**CITY OF CEDARBURG
A MEETING OF THE SITE AND ARCHITECTURAL REVIEW BOARD
TUESDAY, AUGUST 25, 2026 – 8:30 AM**

PLANNERS REPORT

Agenda Item: 5.A.

Request: Favorable recommendation to Plan Commission for approval of new construction infill house plans including acceptance of double driveway/curb cuts.

① Foundation
1/4" = 1'-0"

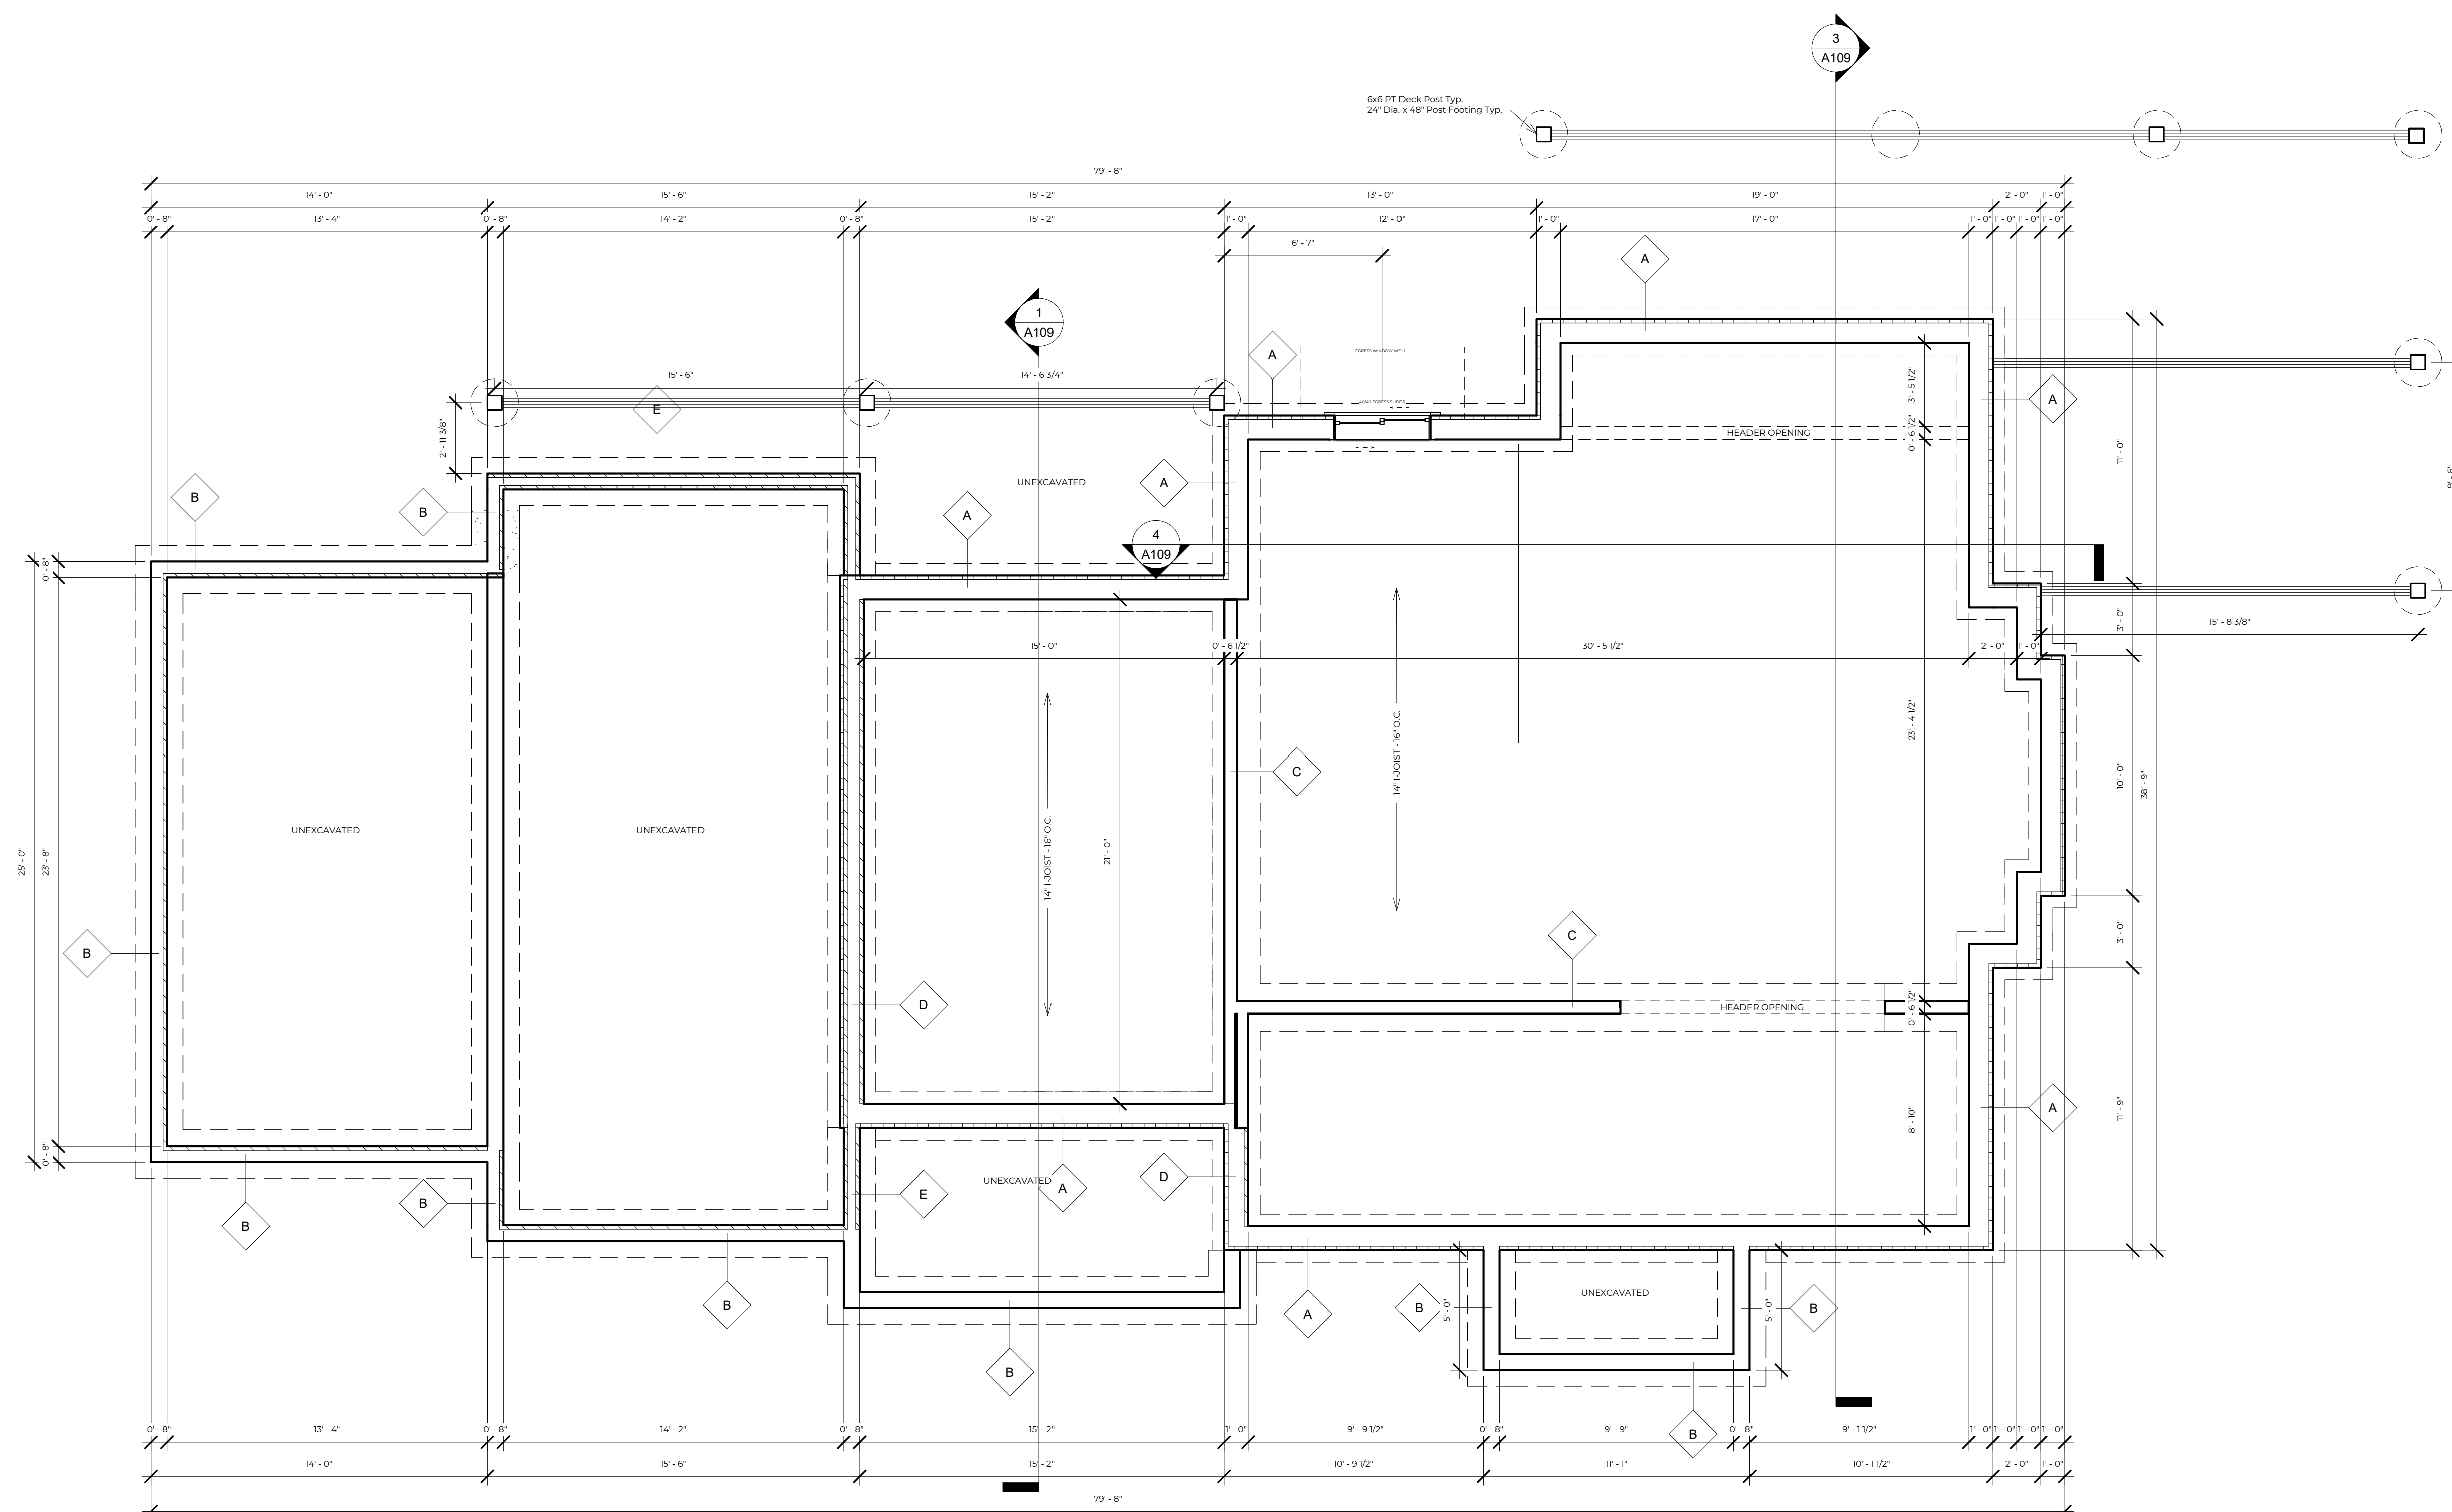
The Board members discussed the architectural design of the proposed residence. Members encouraged the applicants to revise the front elevation by extending the westerly front porch and roofline as far as practicable to create a deeper, more functional porch that would serve as a more prominent and welcoming architectural feature. The Board stated that these revisions would help reduce the visual dominance of the garage doors and create a stronger, more unified front façade. Board members also encouraged the applicants to open up the easterly front entry area to provide a more inviting entrance sequence.

The Board then discussed the proposed use of stone veneer on the garage elevation, expressing concern that the stone appeared as isolated decorative elements that neither related to other stone features on the home nor terminated at logical architectural breaks. Members recommended eliminating the stone accents on the garage unless the material could be incorporated in a manner that created a more cohesive architectural design. The applicant's architect acknowledged the comments and agreed that revisions to the stone application would improve the overall appearance of the residence.

- 4) Applicant to supply the Site and Architectural Review Board (SARB) with a *complete* building materials and colors sample board, including as to overhead garage doors, for this proposed new home.
